Snowtex Sportswear Ltd.

B-65/4, Lakuriapara, Dhulivita, Dhamrai
(23.910371, 90.206833)
3rd March 2021

Observations

Column Layout plan

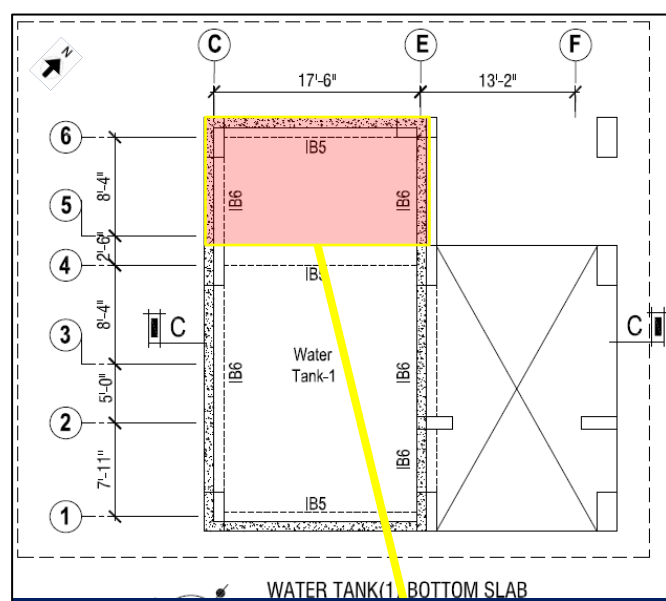
Column at the marked location was found only at ground floor. But in drawing, these columns have been shown up to top floor.
 Factory engineer is required to survey the structures and prepare accurate as-built drawings in compliance with section 1.9.1.2 (Part-6;BNBC)

Overhead water tank -1

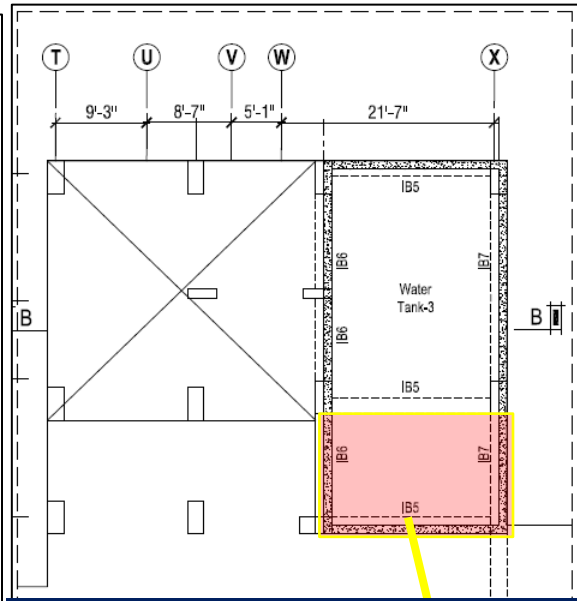
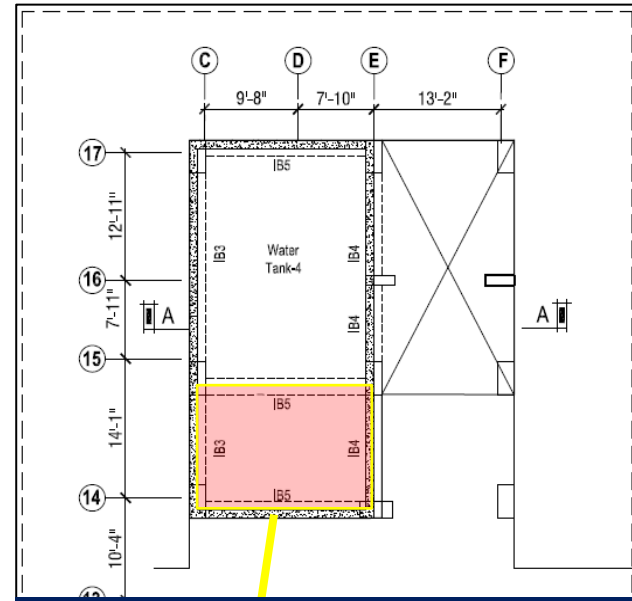
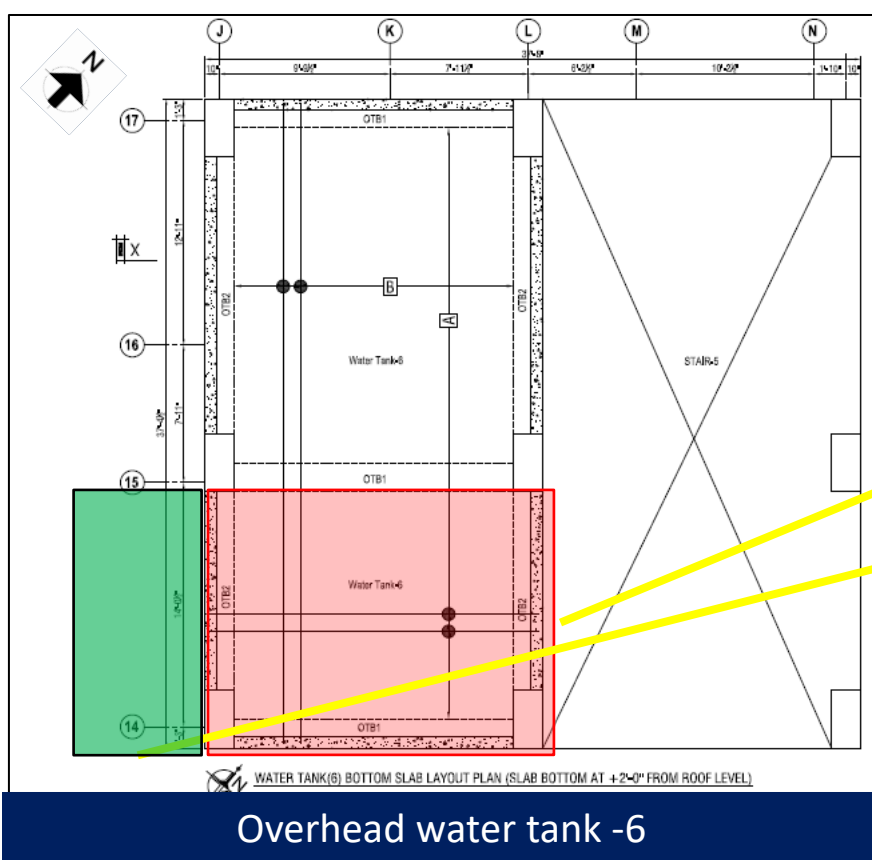
Over head water tank was not constructed as per drawing at the marked location. Factory engineer is required to survey the structures and prepare accurate as-built drawings in compliance with section 1.9.1.2 (Part-6;BNBC).

Over head water tank was not constructed as per drawing at the marked location. Factory engineer is required to survey the structures and prepare accurate as-built drawings in compliance with section 1.9.1.2 (Part-6;BNBC)

Tie-Beam layout

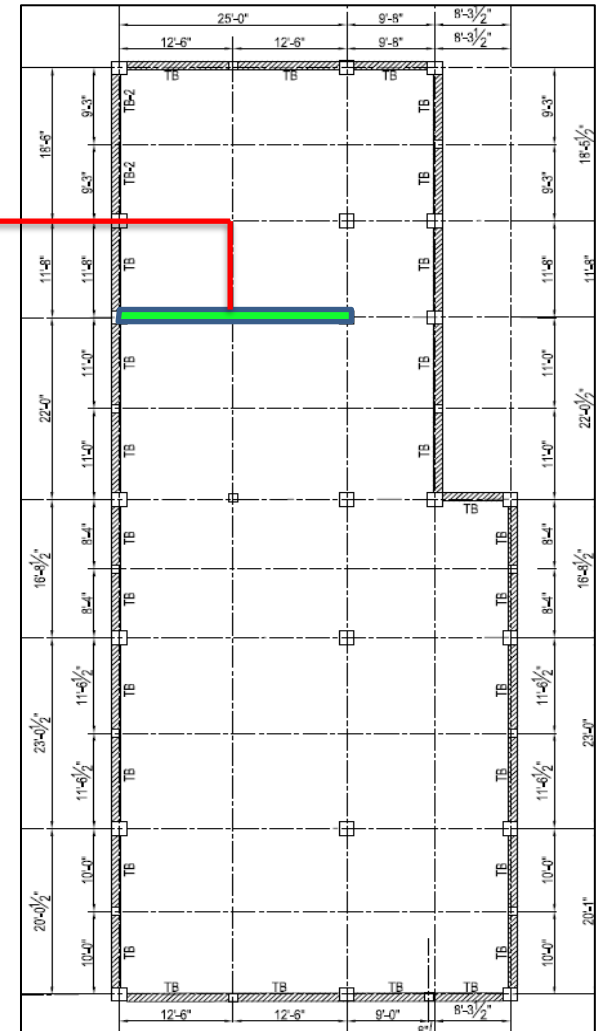
An Additional tie-beam (300mmX550mm) along grid 5A to 5B was found on-site. But no details has been found in provided drawing. Factory engineer is to survey the whole structure and update as-built drawings representing accurate site condition.

Beam layout plan

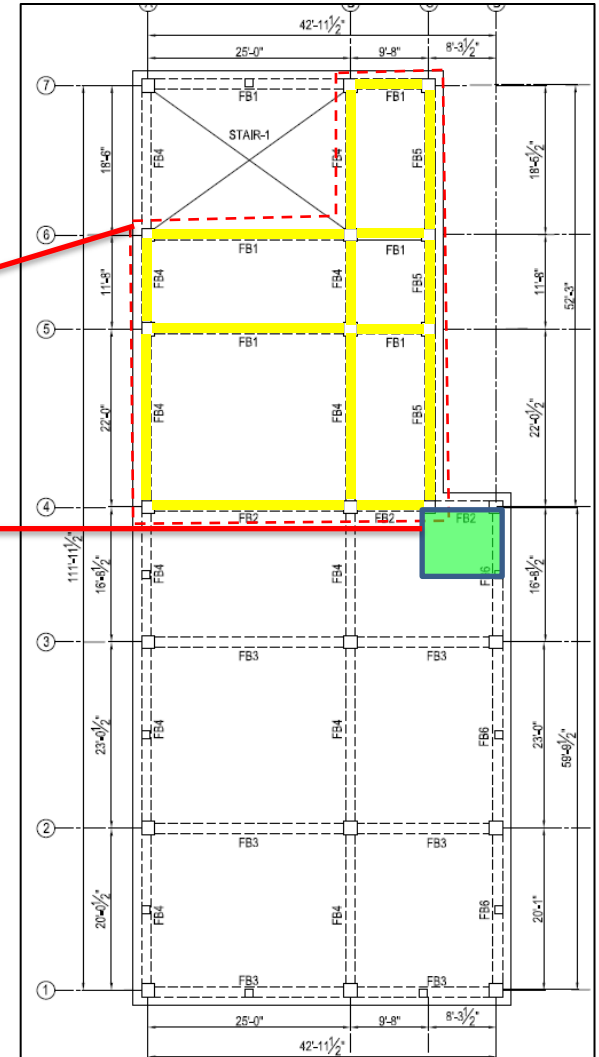
The marked beams detail has not been shown in provided drawing for 1st floor roof level. Also, an undocumented toilet has been found on roof. Factory Engineer is to survey the whole structure and update as-built drawings representing accurate site condition.

Tie-Beam layout

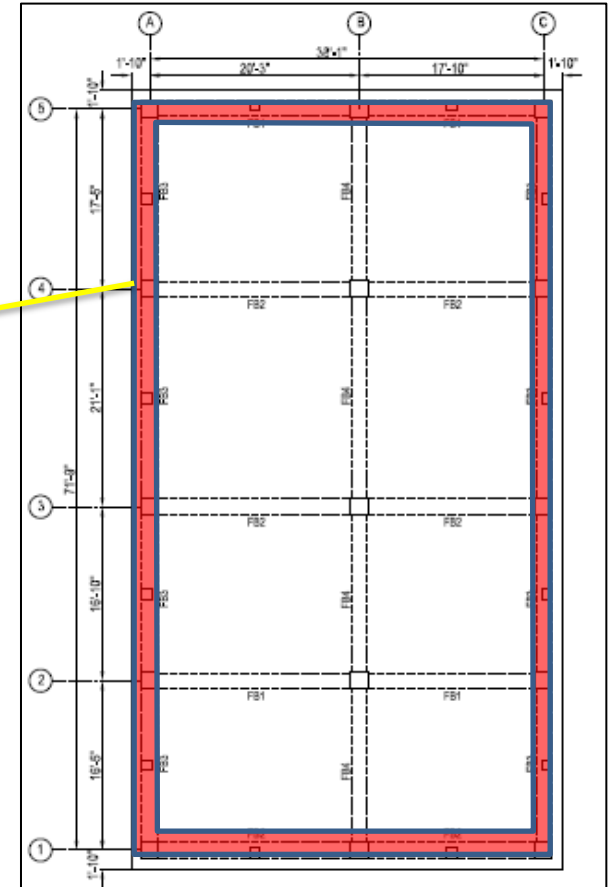
No tie-beam details was found in provided drawing. But on-site 300mmX375mm tie-beam was found all over the periphery. Factory engineer is to survey the whole structure and update as-built drawings representing accurate site condition.
